**AGENDA
PUBLIC WORKS
COMMITTEE**

**MONDAY, FEBRUARY 2, 2015
ROOM 202
5:30 P.M.**

5. Award of Contract for Project 14-1424 Southport Beach House Roof Replacement Rebid (7825 1st Avenue) to Carlson Racine Roofing & Sheet Metal, Inc. (Racine, Wisconsin) in the amount of \$316,000.00. (Park Funds Only) **(District 12)** *(Park Commission approved 5-0)*

1. Plan Set

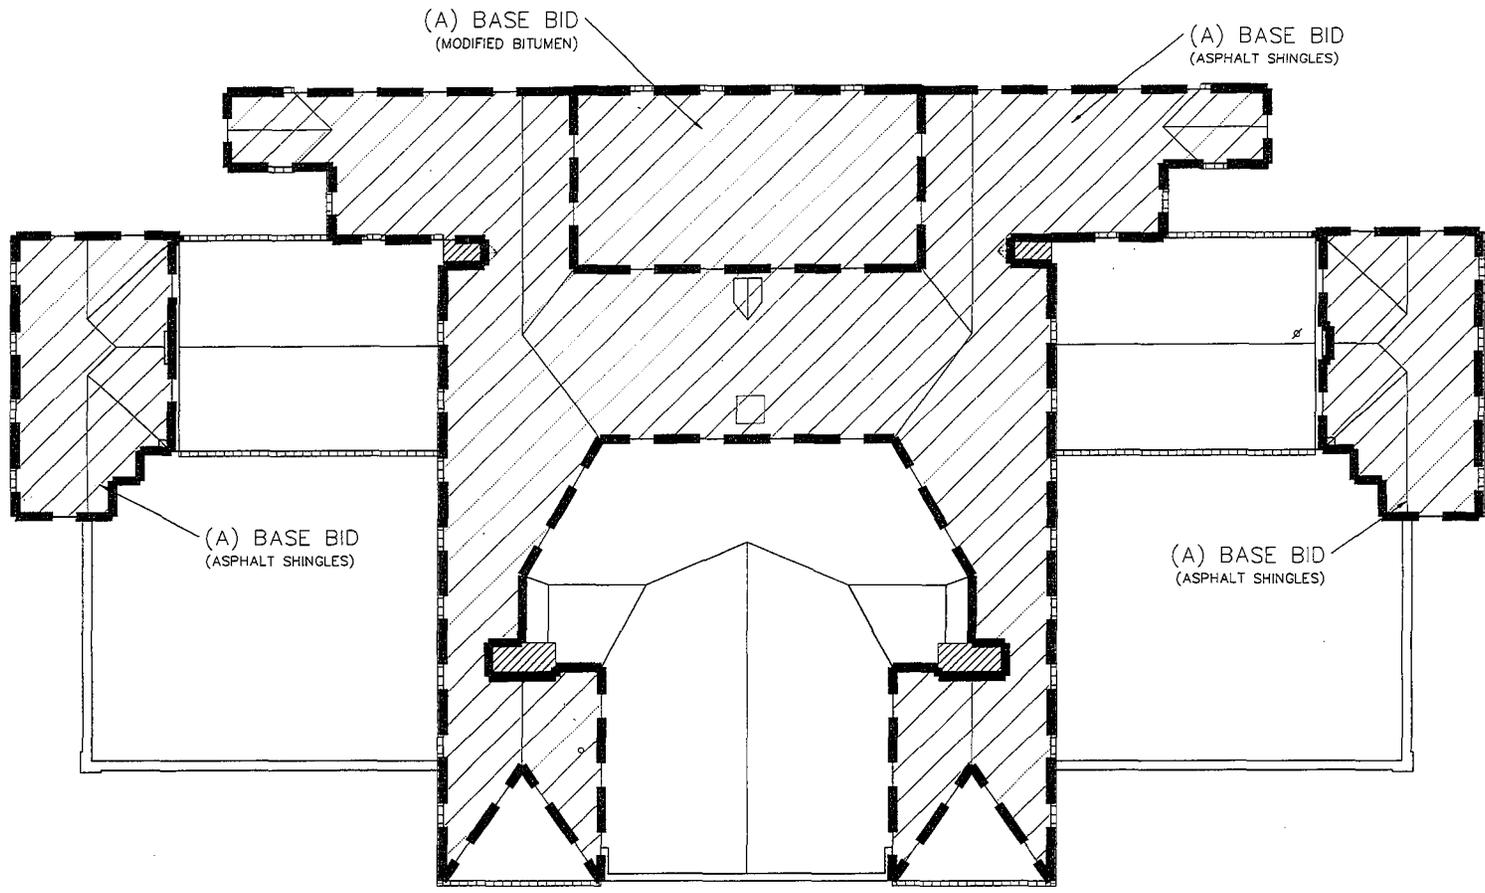
Add the attached pages ADDM 1 – A1.1, ADDM 1 – A1.2, and ADDM 1 – A1.3.

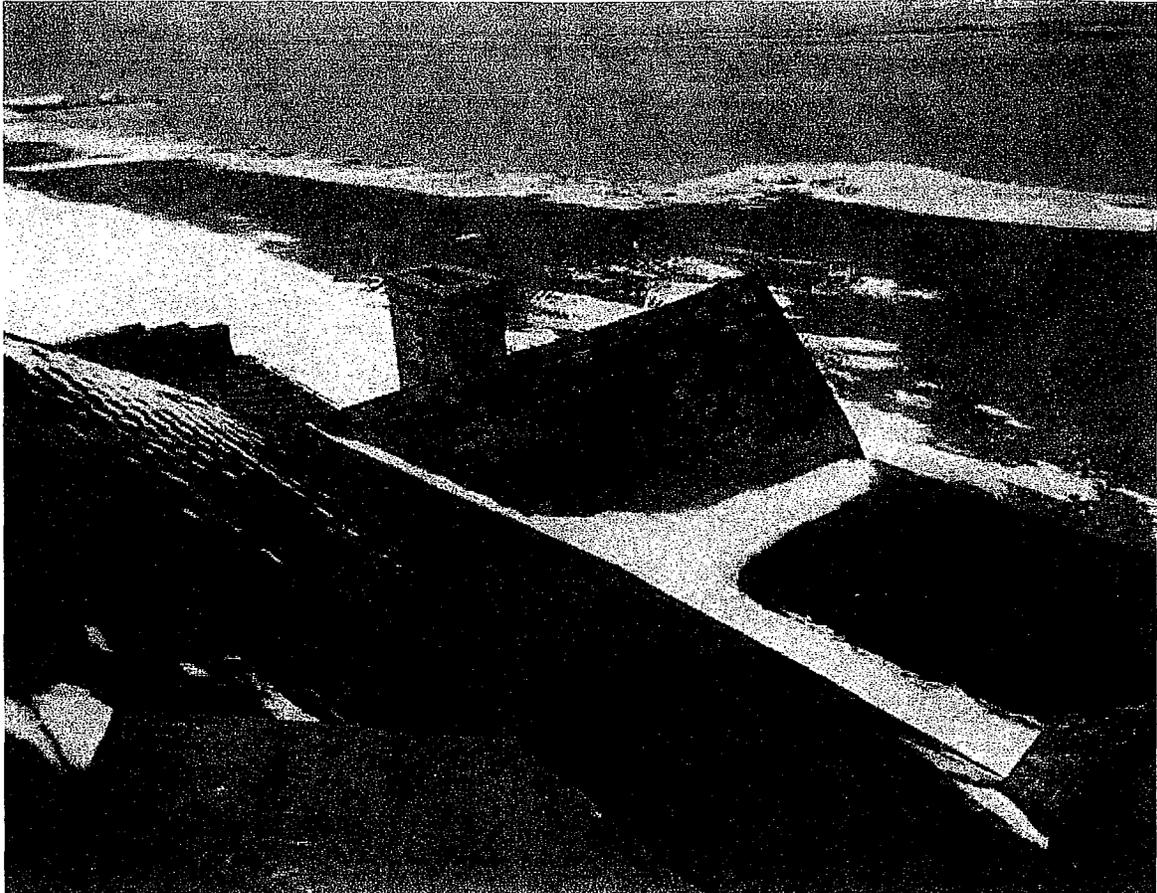
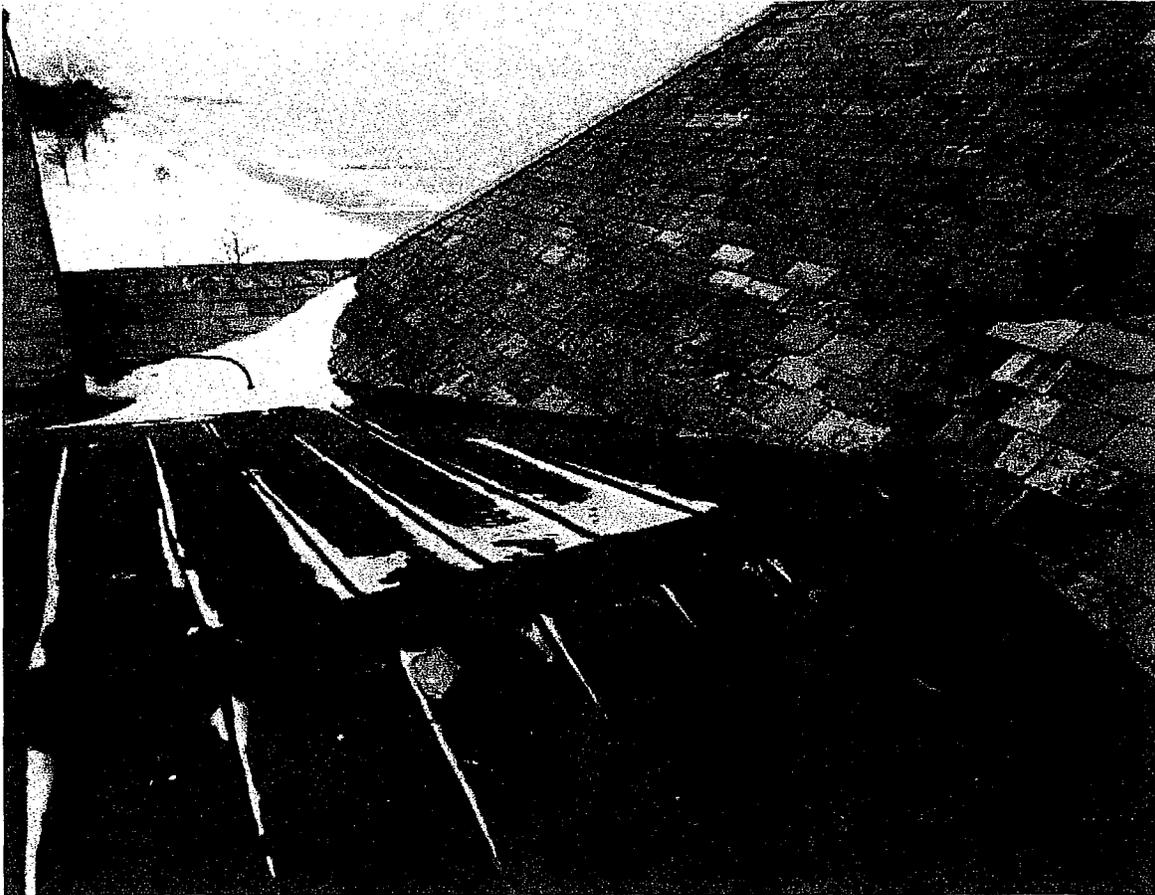
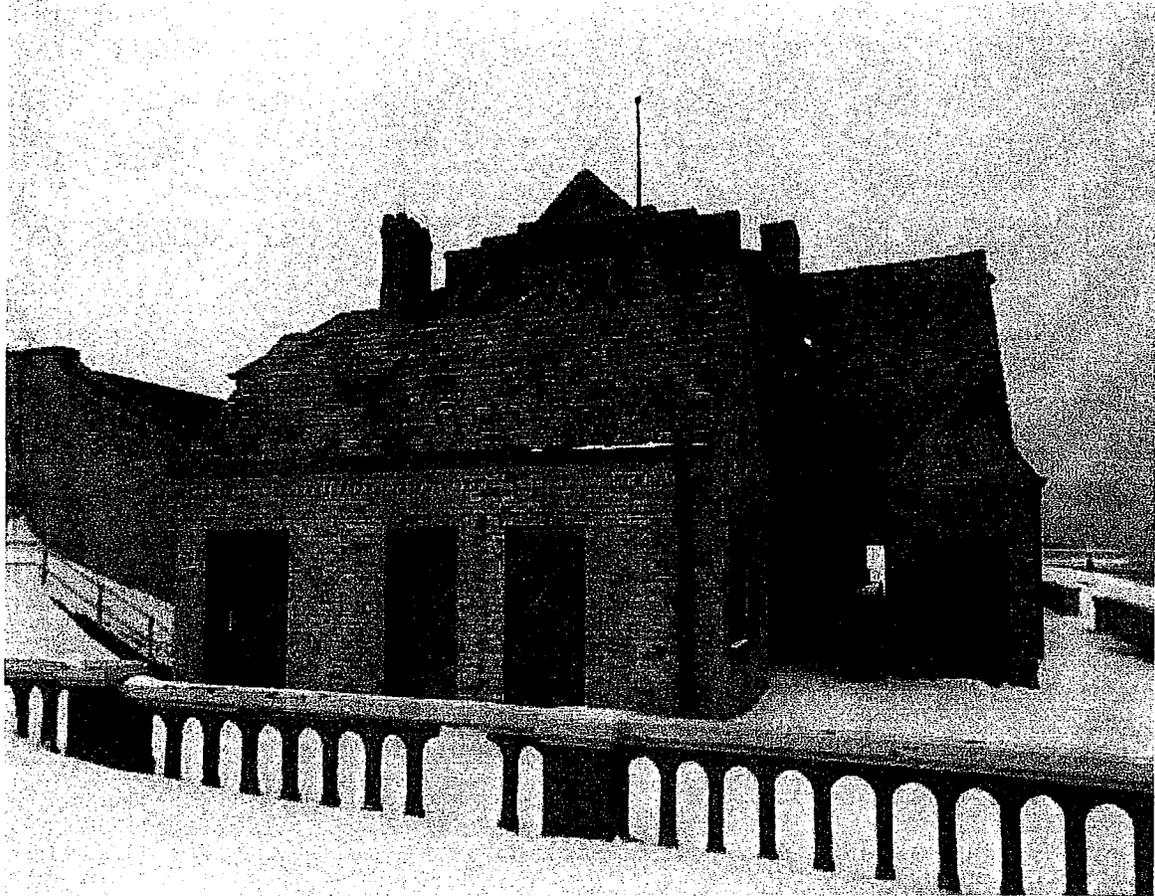
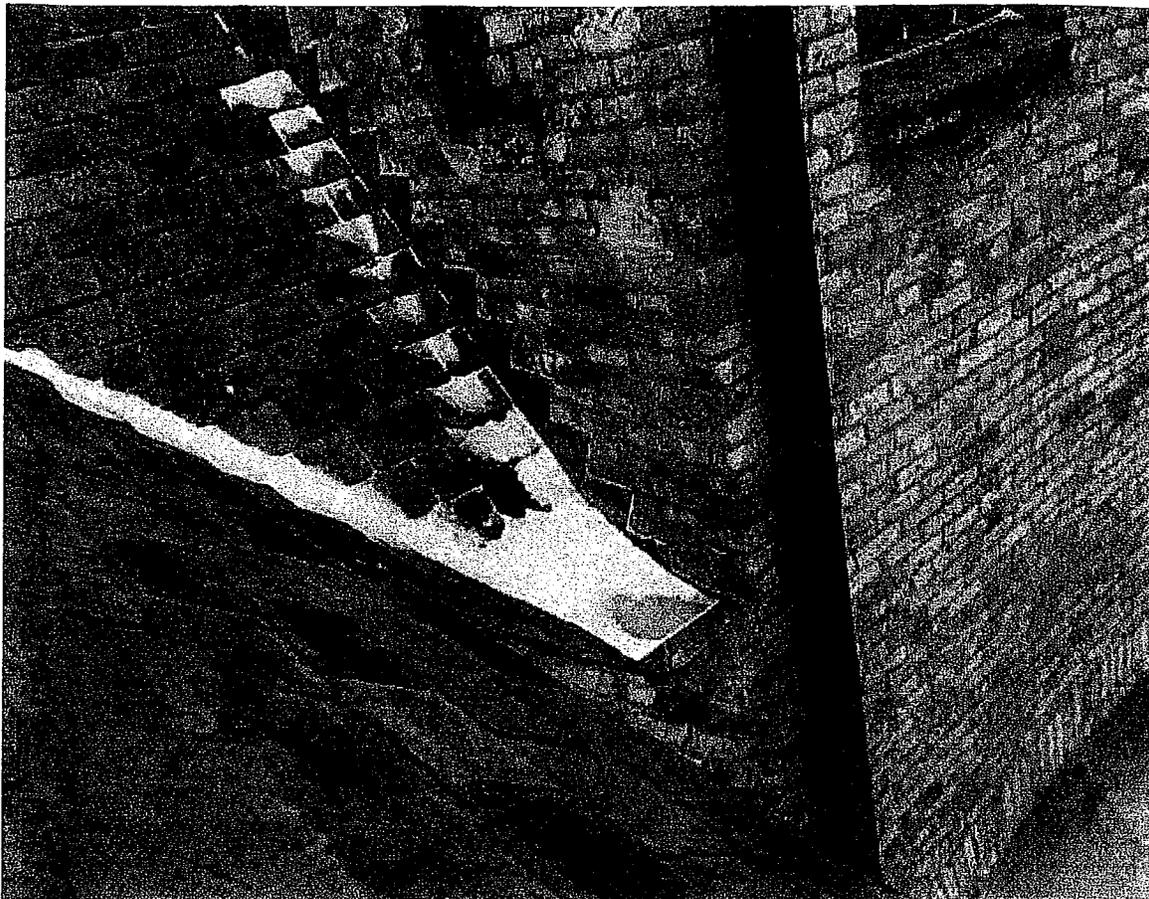
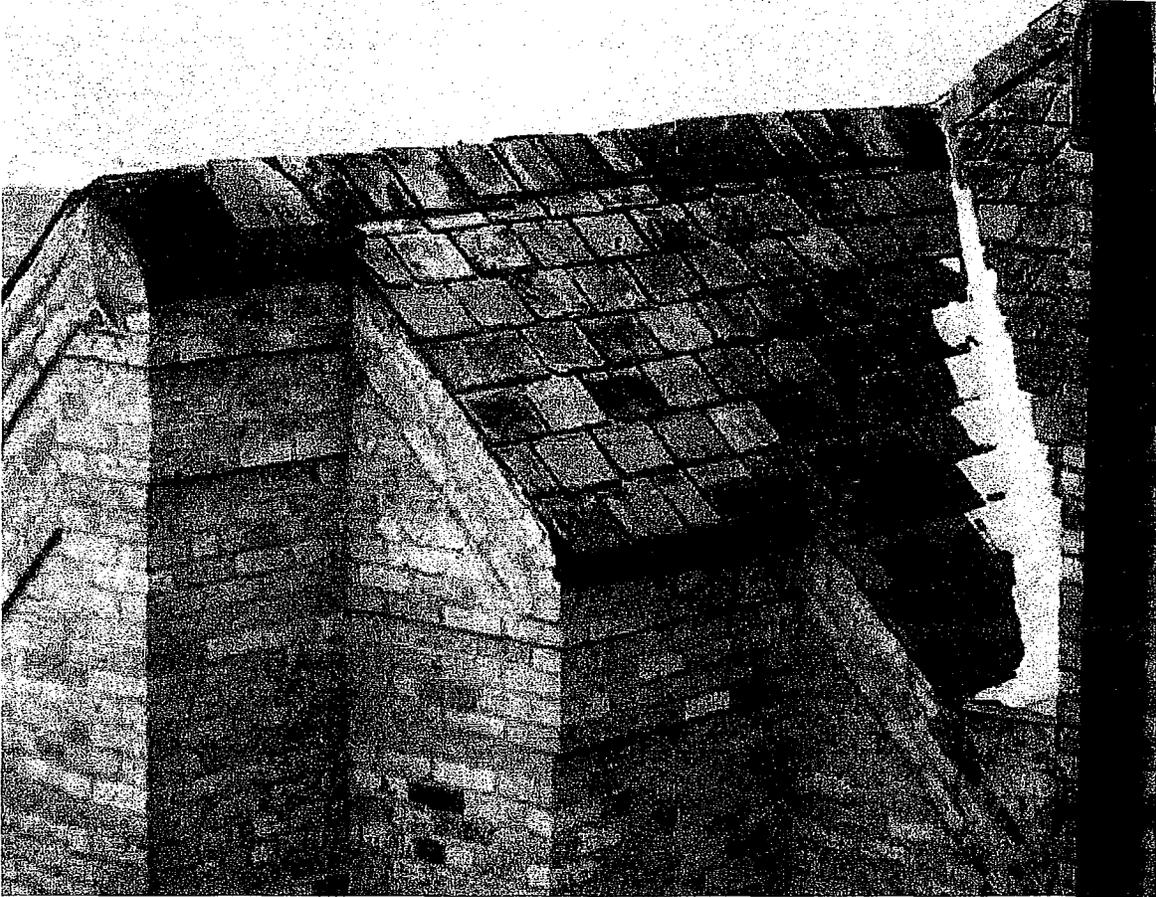
In an effort to provide a general perspective of the slate I have attached several photographs depicting their condition and visible nature of the extensive repairs completed over the years with slates which do not match those originally installed, preventing the wholesale salvage and reinstallation of the existing slates.

ADDM 5-1

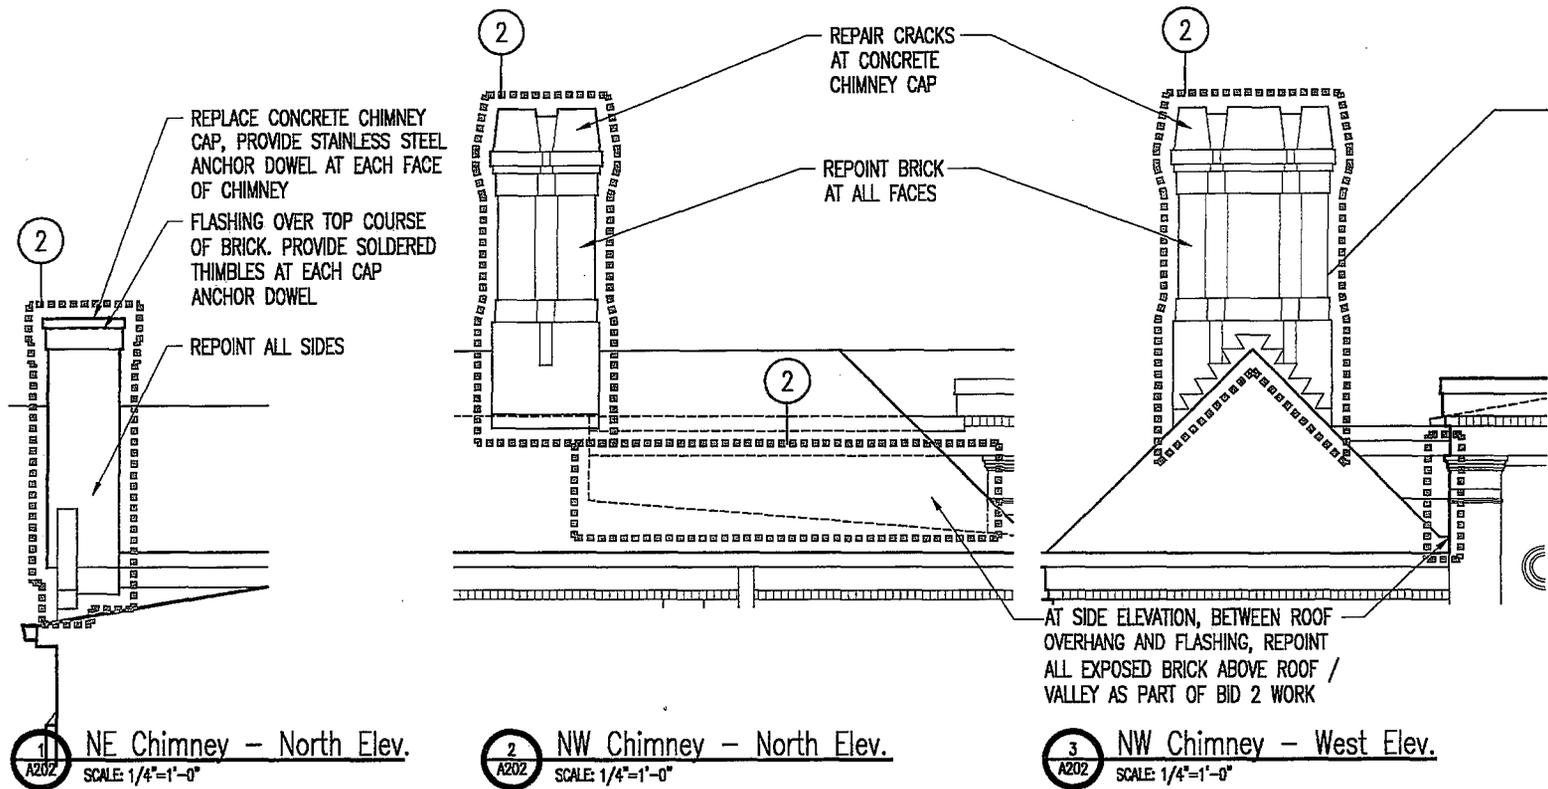
Replace drawings from Addendum 1 (ADDM1-A1.1, ADDM 1-A1.2, ADDM 1-A1.3) with the attached drawings ADDM 5-1, ADDM 5-2, ADDM 5-3, ADDM 5-4, ADDM 5-5, ADDM 5-6, ADDM 5-7 and ADDM 5-8. These drawings correspond directly to the revised Bid Form.

ADDM 5-2

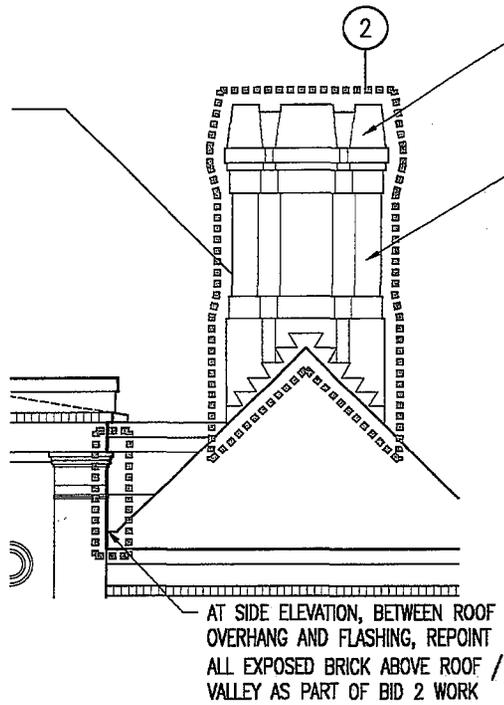
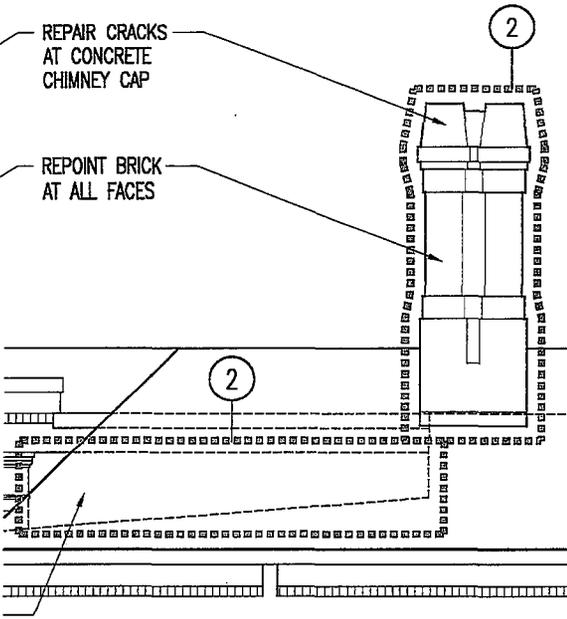
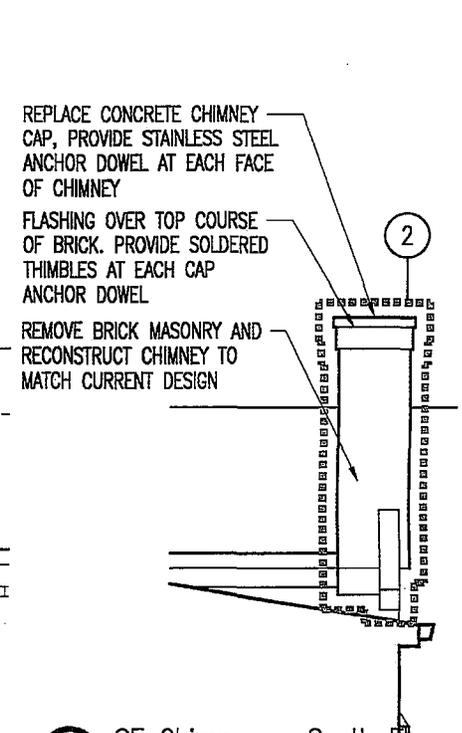
- a. Repoint, repair and clean both chimneys as shown in the plans.
 - b. See section 2 “Maintenance of Unit Masonry”
